UNITED STATES PATENT AND TRADEMARK OFFICE

APPLICATION NO.	FILING DATE	FIRST NAMED INVENTOR	ATTORNEY DOCKET NO.	CONFIRMATION NO.
10/577,127	04/25/2006	Satoshi Seo	0756-7662	8187
31780	7590	06/18/2008	EXAMINER	
ERIC ROBINSON			PATTON, PAUL E	
PMB 955			ART UNIT	
21010 SOUTHBANK ST.			PAPER NUMBER	
POTOMAC FALLS, VA 20165			2822	
			MAIL DATE	DELIVERY MODE
			06/18/2008	PAPER

Office Action Summary	Application No. 10/577,127	Applicant(s) SEO ET AL.	
	Examiner PAUL E. PATTON	Art Unit 2822

DETAILED ACTION

FIG. 3

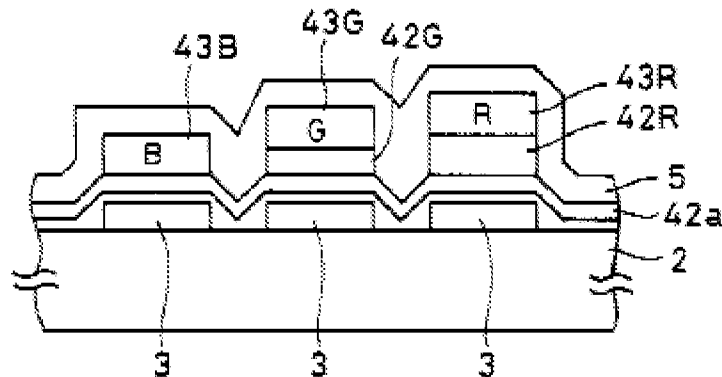
5. As to claims 1, 2, 3, 9, 10 and 12, Fukuda discloses and shows and shows (Fig 3) a light-emitting device have at least first and second light emitting elements exhibiting different emission colors., each of the first and second light-emitting elements comprising: a first electrode and a second electrode; and a first layer, a second layer and a third layer which are formed over the first electrode and a second electrode over the first layer, the second layer and the third layer, wherein the first layer serves as a layer generating holes, the second layer serves as a layer including a light-emitting layer, and the third layer serves as a layer generating electrons, and wherein a thickness of the first layer of the first light-emitting element is different from that of the second light-emitting element and the first and second thickness are different from the third light-emitting element. (Column 5, lines 24-36 & Column 9. line 62-column 11 line 59).

6. Fukuda does not explicitly disclose that the first electrode has a non-light-transmitting property.
7. Miura is related to a similar light-emitting device and discloses that the first electrode is a non-light-transmitting layer (reflective layer). (Paragraph [0084]).

FIG. 3

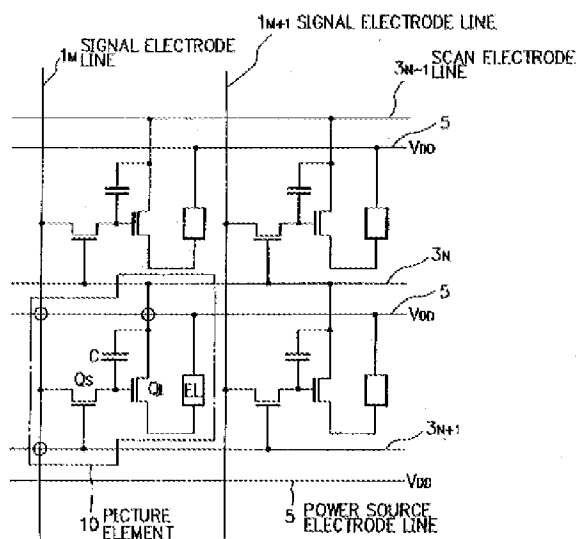
15. Utsugi discloses and shows (Fig 3) the very well known circuit comprising a plurality of transistors provided at interconnection portion formed by signal lines and scanning lines.

16. Utsugi is evidence that a person of ordinary skill in the art would find a reason, suggestion or motivation to use a plurality of transistors provided at interconnection portion formed by signal lines and scanning lines.

17. Therefore, it would have been obvious to one of ordinary skill in the art at the time the invention was made to modify Fukuda and Kido by using a plurality of transistors provided at interconnection portion formed by signal lines and scanning lines for advantages such as improved display stability according to the teachings of Utsugi. (Column 3, line 66 – column 4, line 4).

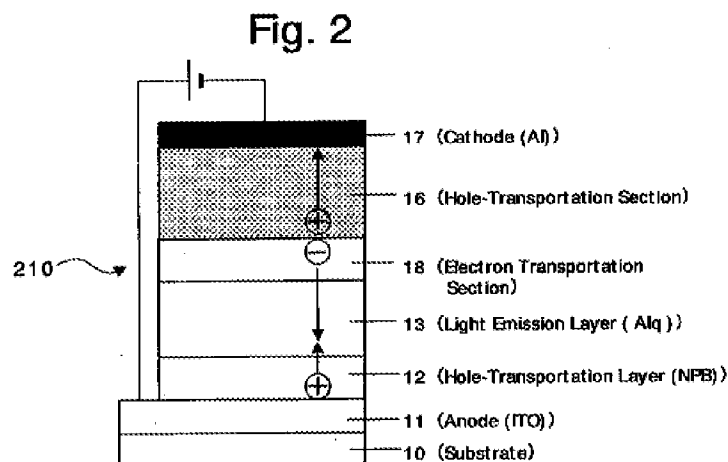
19. Matsumoto discloses and shows (Fig 2) an organic light emitting device comprising a fourth layer (16) as a layer for generating holes.

20. Matsumoto is evidence that a person of ordinary skill in the art would find a reason, suggestion or motivation to use a fourth layer as a layer for generating holes.

21. Therefore, it would have been obvious to one of ordinary skill in the art at the time the invention was made to modify Fukuda, Miura, Kido and Utsugi by using a fourth

layer as a layer for generating holes for advantages such as lowered excess drive voltage according to the teachings of Matsumoto. (Paragraphs [0025] & [0026]).
